Subdivision Application

July 9, 2019

The subject property is about 52.80 acres in size and zoned RA (Residential Single Agriculture). The applicant is proposing to divide the subject property into 214 single family residential lots (within 11 Phases/Sections).

COBURN GRAND VIEW ESTATES

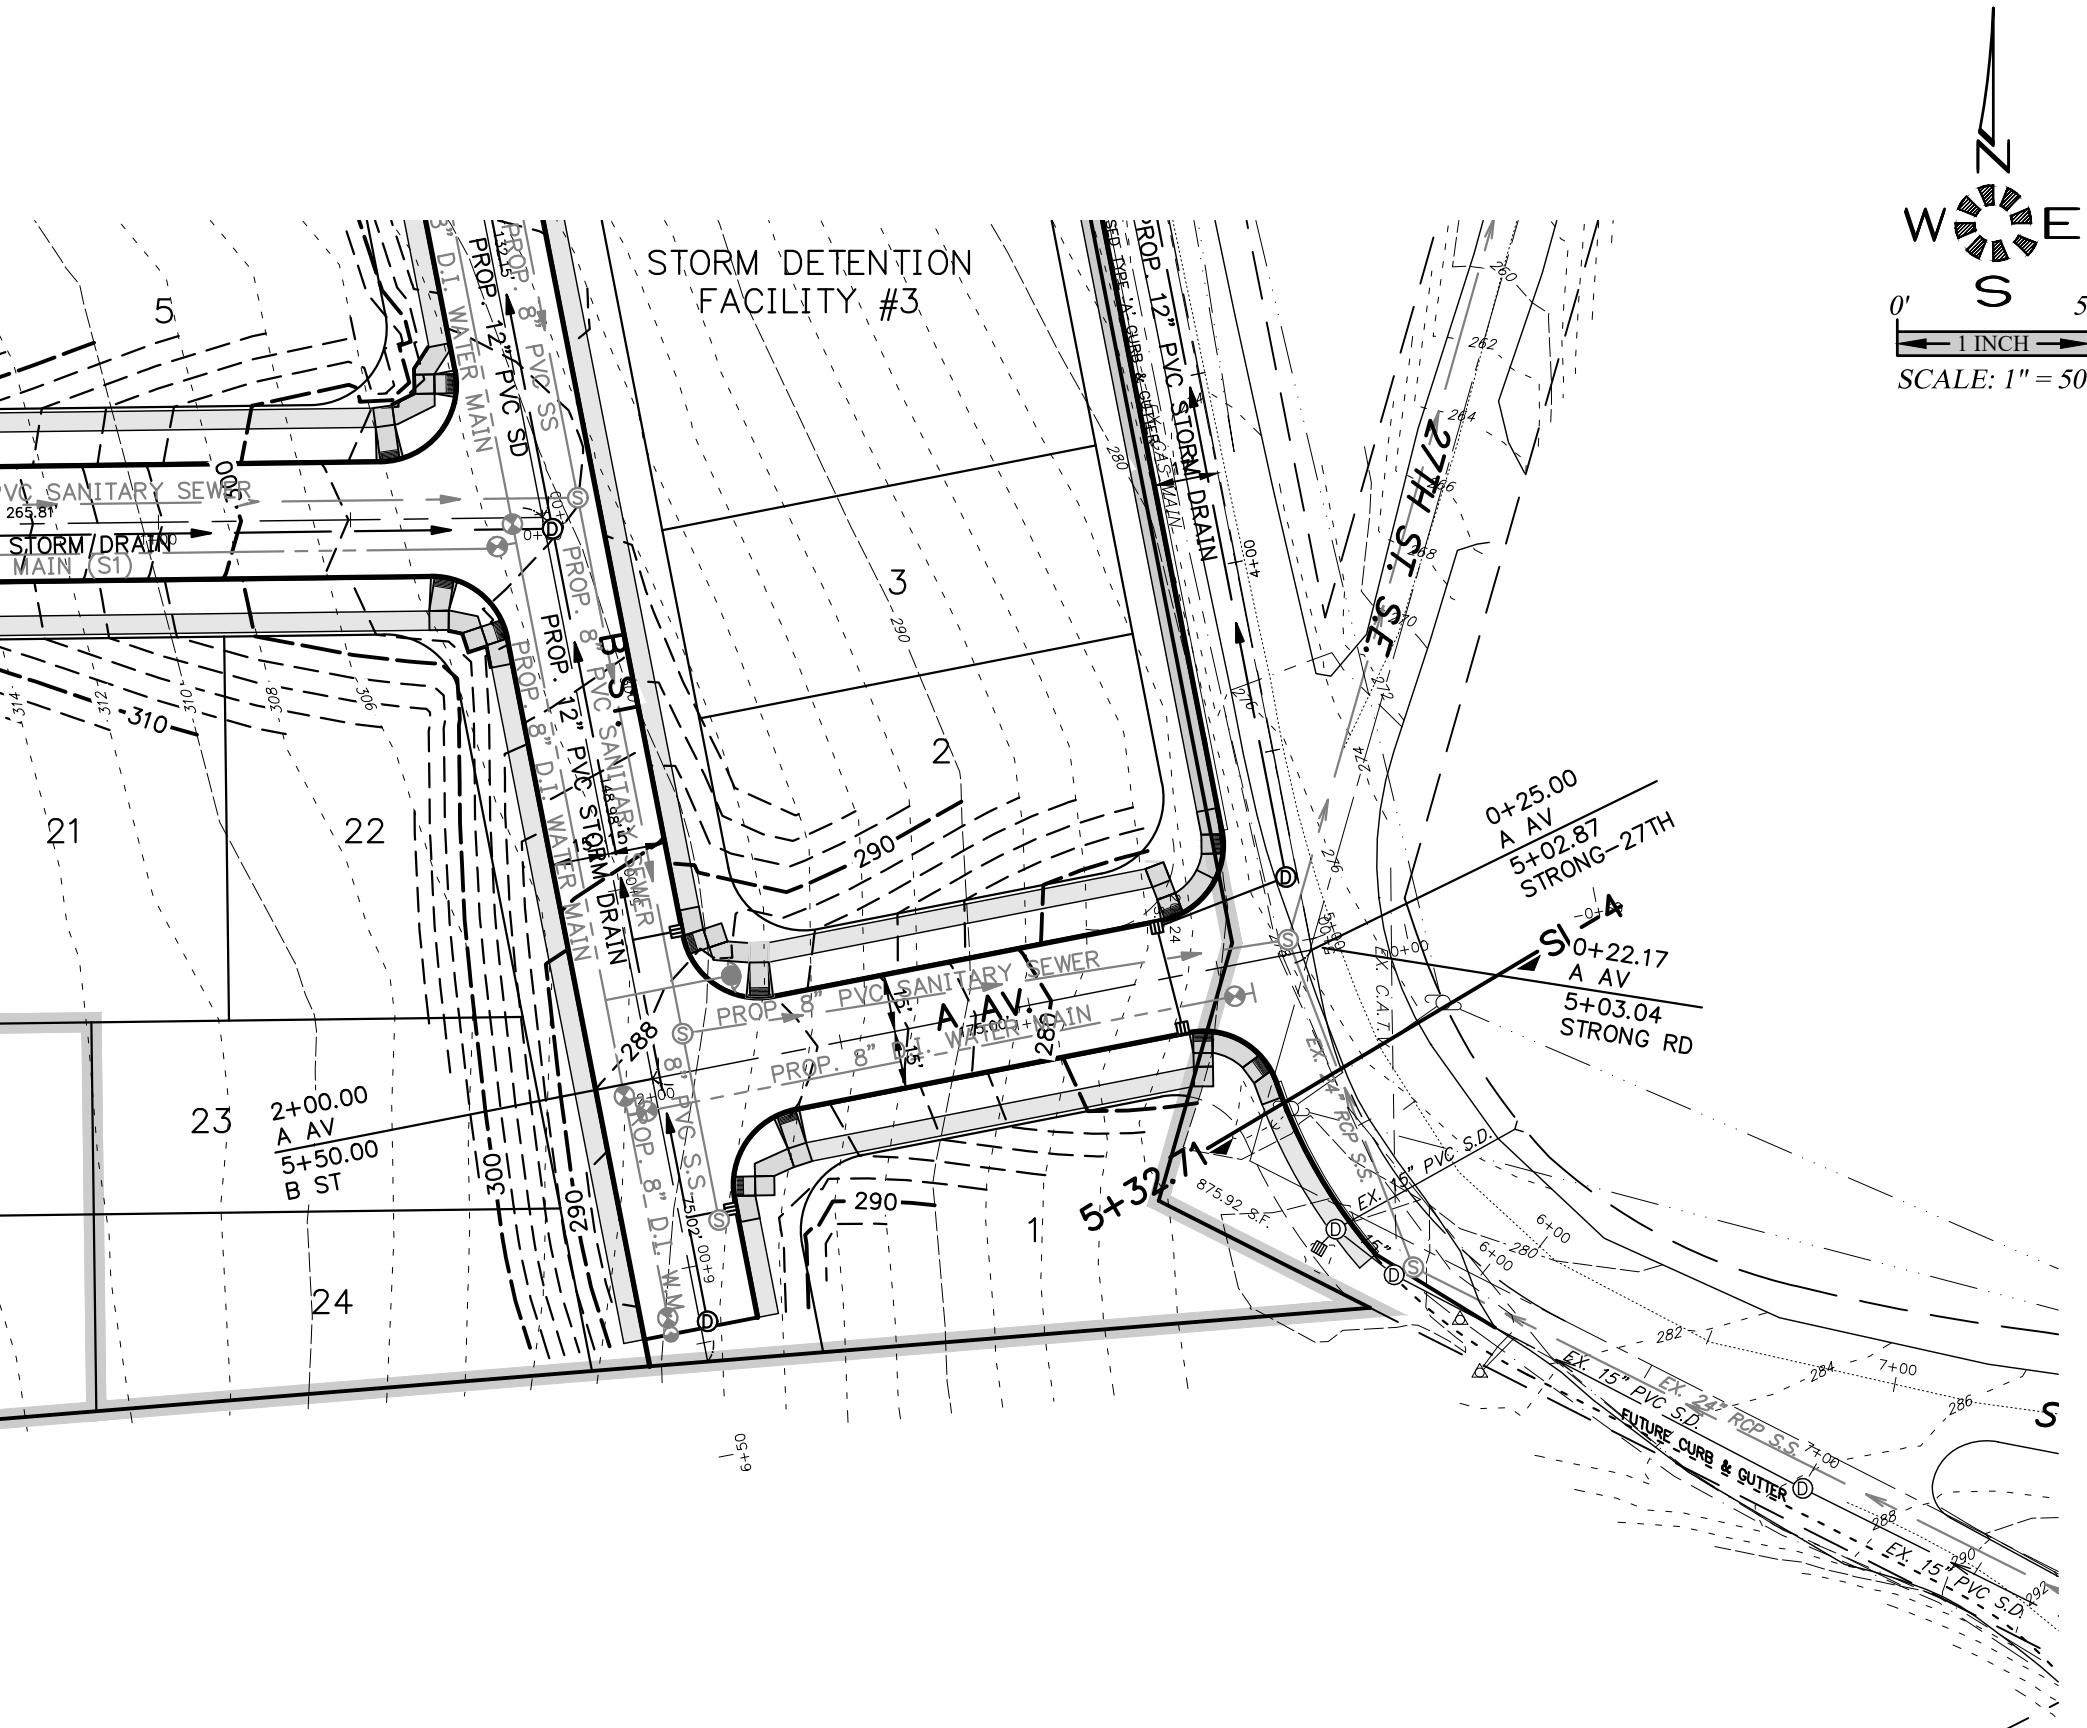
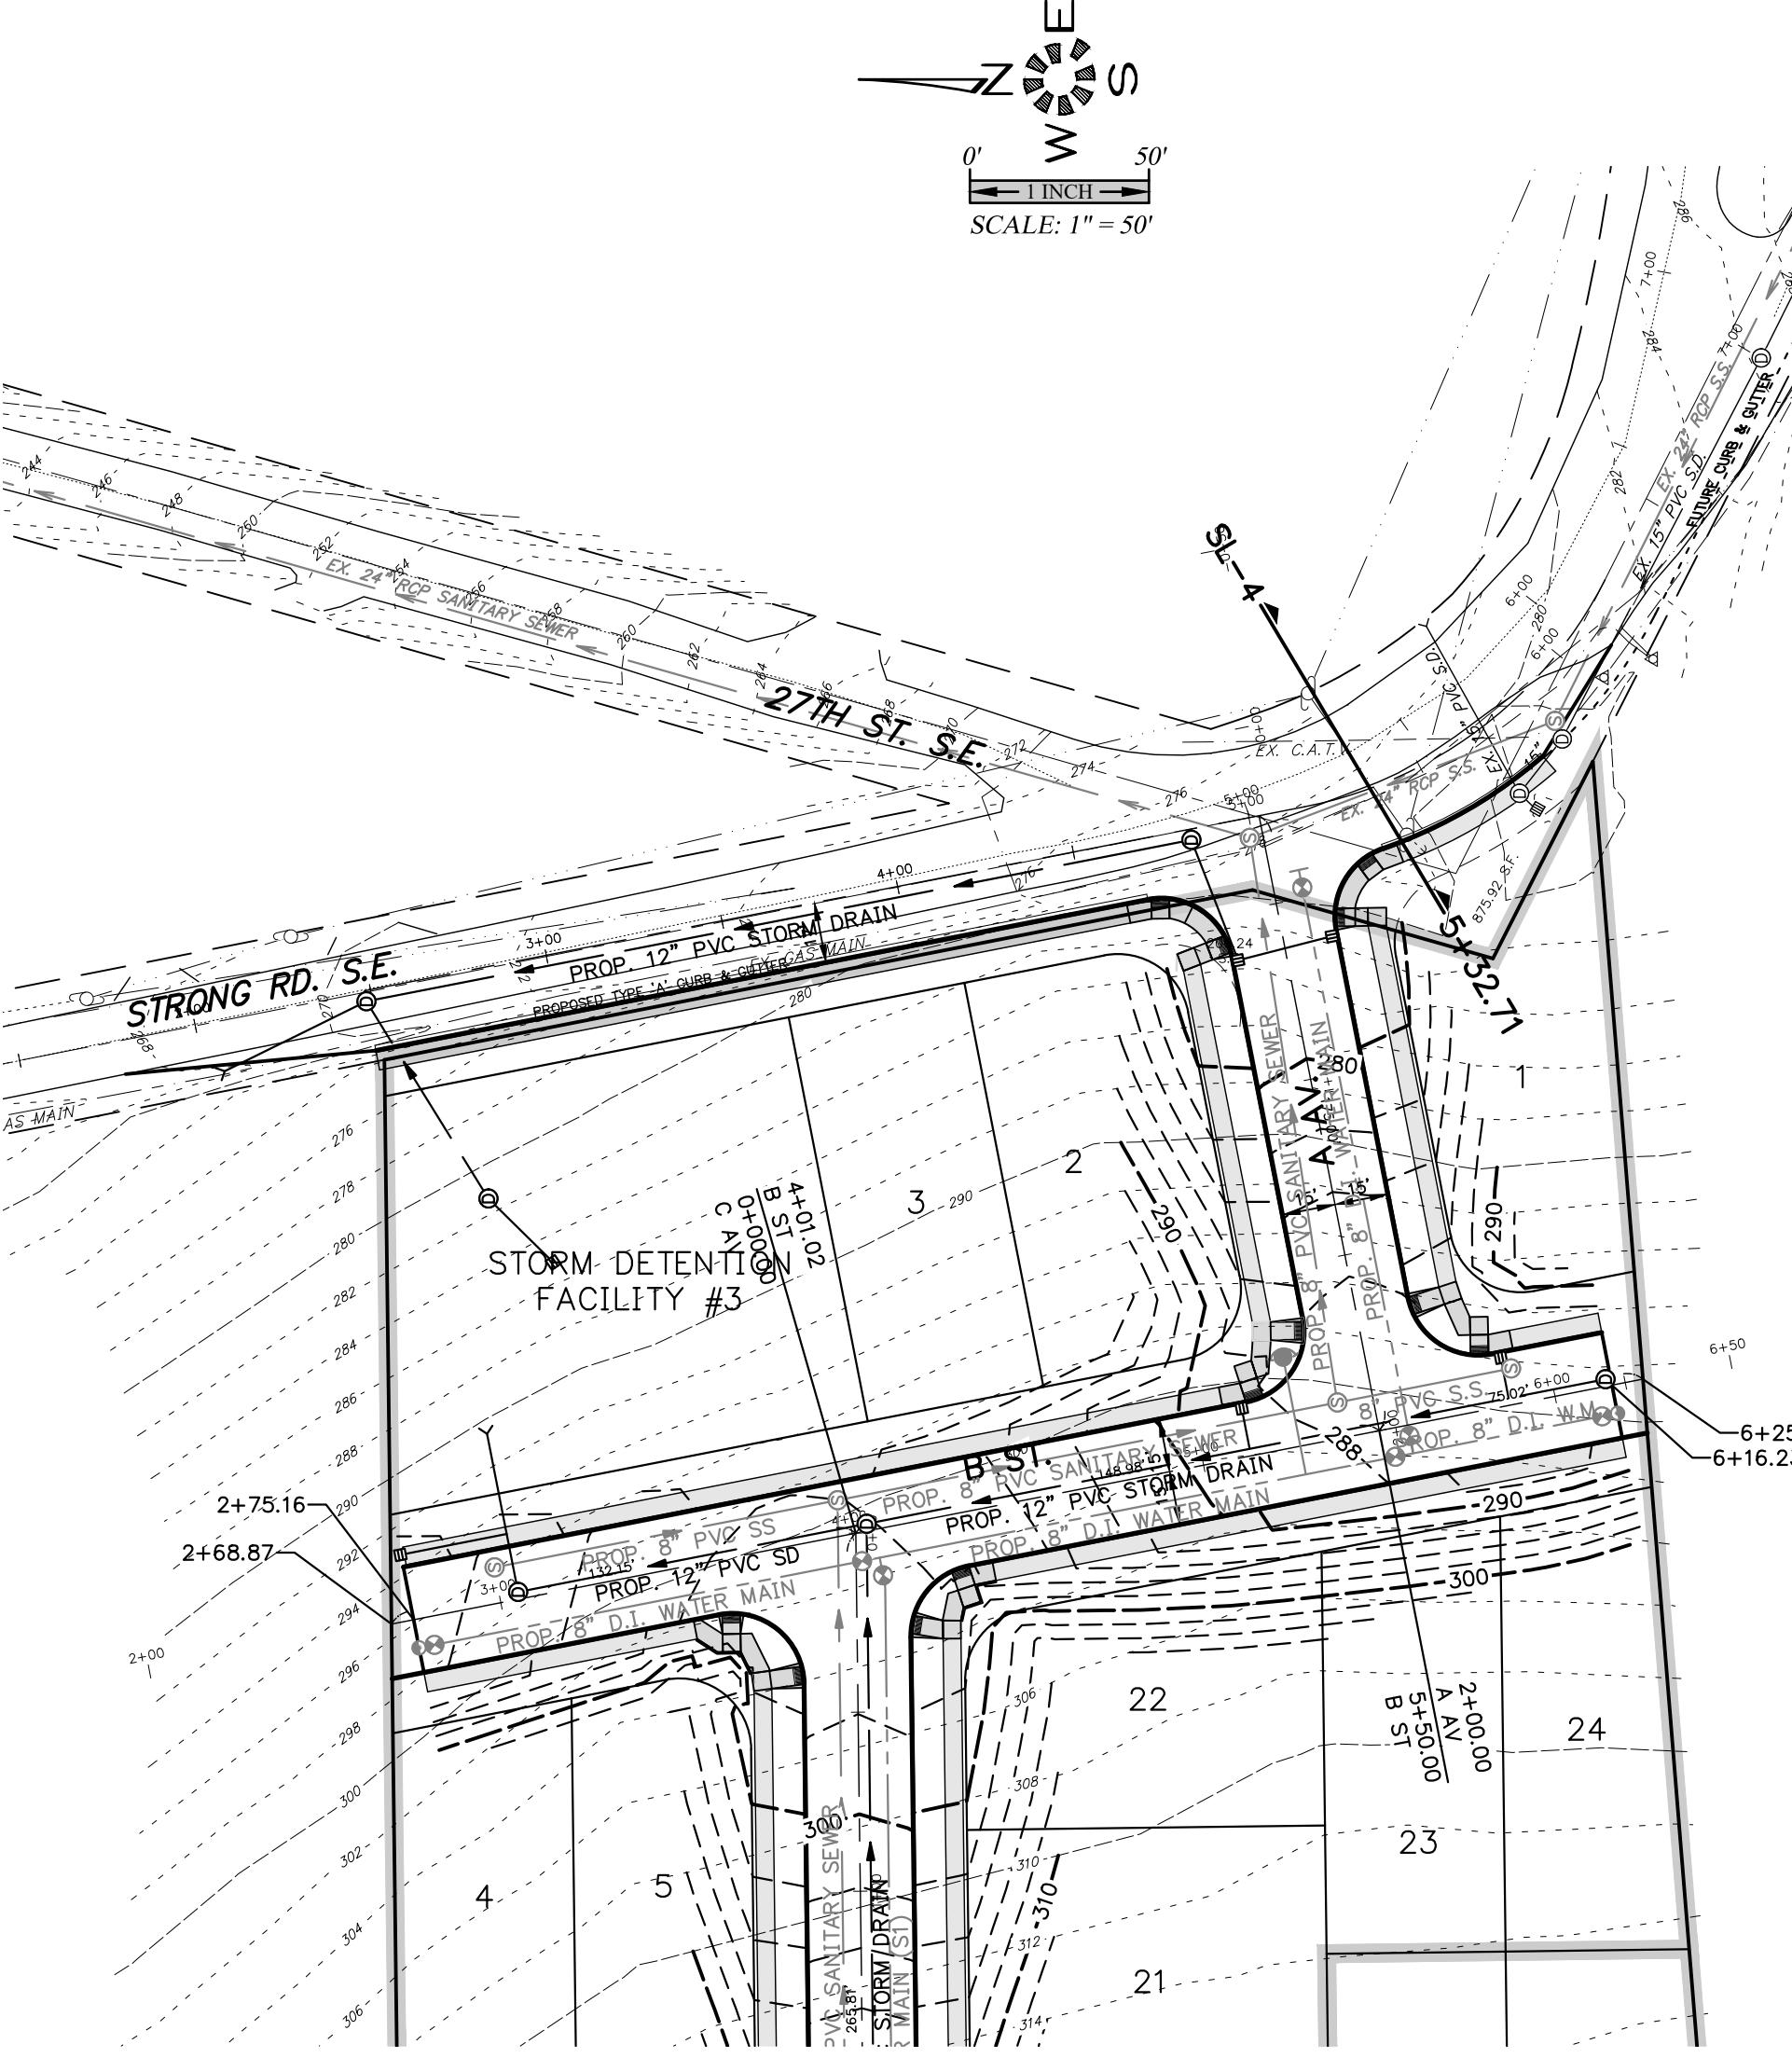
- (A)** The applicant is requesting an adjustment to street grades. As shown on Sheet 1 of 1, Slope Exception Areas Plan, sections of A Avenue, C Avenue, I Avenue, H Street, M Street, J Avenue, N Street, O Street, and P Avenue within the subdivision will have sections of the roadway with up to a 15% street grade. Due to the topography of the site and the proposed street alignment with existing streets, several streets will exceed the 12% street grade allowed. The areas proposed for slopes in excess of 12% are denoted on the plans and will not exceed a single run length of 200 feet.

- The natural grade within the subject property exceeds 12 percent in many areas. The applicant shall provide preliminary vertical street alignments to demonstrate compliance with the minimum standard of 12 percent street grade for local streets.*

- Plans have been revised and/or provided to show the street alignments and compliance with street grade.**
- Several lots will need to provide sprinklers, if the 12 percent street grade cannot be met. This includes K Street, and N Street. In addition, several Fire Department turnarounds need to be shown; the end of I Avenue, flag lot accessway, and Q Avenue.*

- The site plans have been revised and a design exception to street grade has been requested.**
- The proposed plan shows construction of a 50-foot wide right-of-way for M Street and a 40-foot wide right-of-way for K Street. The applicant shall modify the proposed plan to meet street standards, or submit findings indicating the necessity for the use of alternative street standards pursuant*
